QUALITY ASSURANCE -- NON-CONFORMANCE REPORT

Report No: NCR-000419

Reference Description: Excessive interpass temperature during repair of North Tower, Lift 3, AB corner seam weld

Job Name: SAS Superstructure

Description of Non-Conformance:

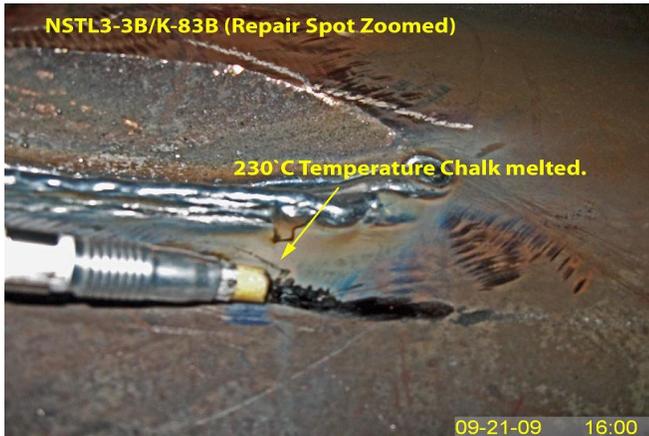
During In-Process Visual Testing (VT) of weld repairs on North Tower, Lift 3, AB corner seam weld NSTL3-3B/K-83, QA observed that the temperature of adjacent base metal was above the maximum allowable interpass temperature (230 C). A 230 degrees Celsius temperature crayon melted when applied to the adjacent base material. The repair was being performed in presence of ZPMC Quality Control Personnel.

ZPMC will provide NDT documentation which shows that the repair weld was not adversely affected by the increased interpass temperature. Documentation will be submitted when available. ZPMC requests that this proposed action be approved, with action pending.

ZPMC is providing NDT documentation of the corner seam weld which was performed more than 72 hours after the non conformance was observed. The documentation shows that the weld is acceptable. ZPMC acknowledges that in this case the interpass temperature exceeded the maximum allowable temperature. The ZPMC QA Department has discussed this non conformance with the production team responsible for this non conformance and stressed the importance of controlling the interpass temperature, and following the WPS. The QC inspector was reminded to ensure compliance with the approved WPS when observing welding. Based on this ZPMC requests closure of this NCR.

Description of Non-Conformance:

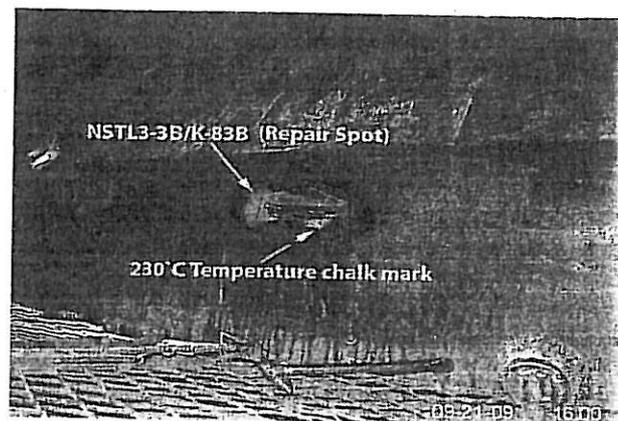
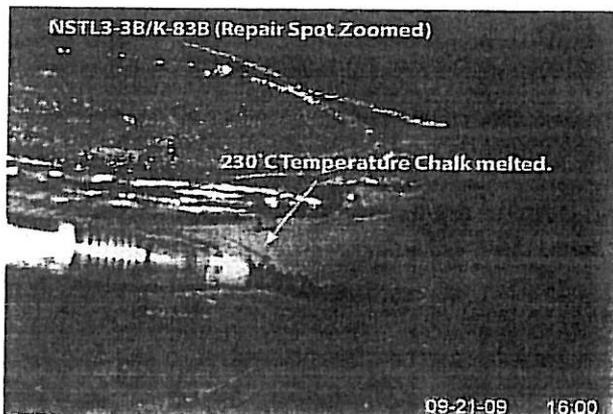
During In-Process Visual Testing (VT) of weld repairs on North Tower, Lift 3, AB corner seam weld NSTL3-3B/K-83, QA observed that the temperature of adjacent base metal was above the maximum allowable interpass temperature (230 C). A 230 degrees Celsius temperature crayon melted when applied to the adjacent base material. The repair was being performed in presence of ZPMC Quality Control Personnel.

ZPMC has instructed the production personnel to improve the control of interpass temperature. Furthermore, NDT reports have been submitted indicating that the affected weld is sound.

WELD NUMBER: NSTL3-3B/K-83A/B

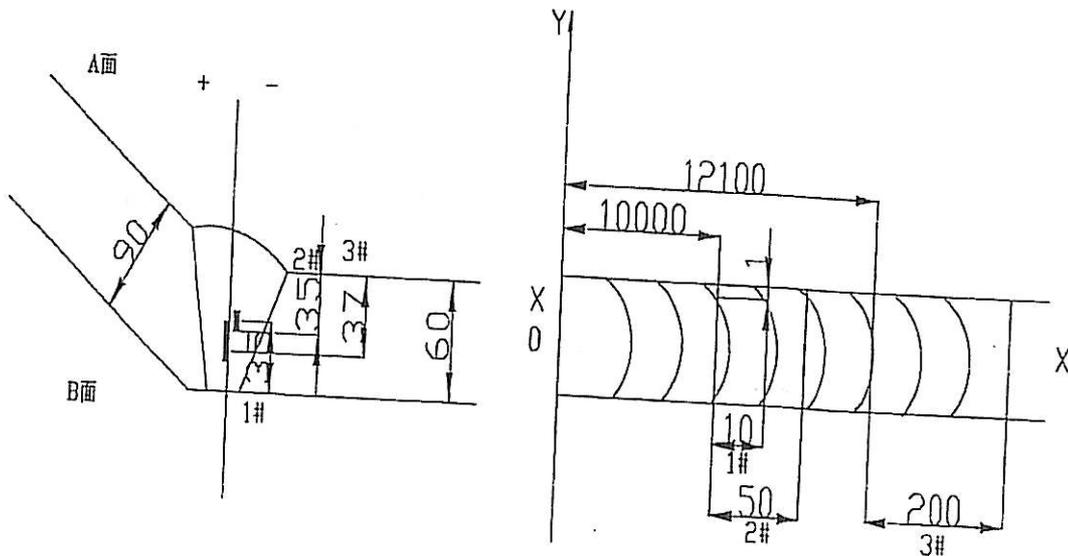
Rejected indication found by ultrasonic inspection at third time.
(UT探伤返修第三次。) NSTL3-3B/K-83A/B

1. 碳刨打磨后, 要圆滑过度, VT和MT确认所有的缺陷已经去除;
 2. 教导在烧熔透焊缝和焊道清理时, 焊工必须负责任;
 3. 关键焊缝返修时, 主要的QC负责人要在现场;
1. Grind smoothly transition after gouging. Perform VT and MT to ensure all the defects have been removed.
 2. Instruct the welder that it is his responsibility to produce sound welds and perform interpass cleaning.
 3. Greater QC presence during critical welding operations.
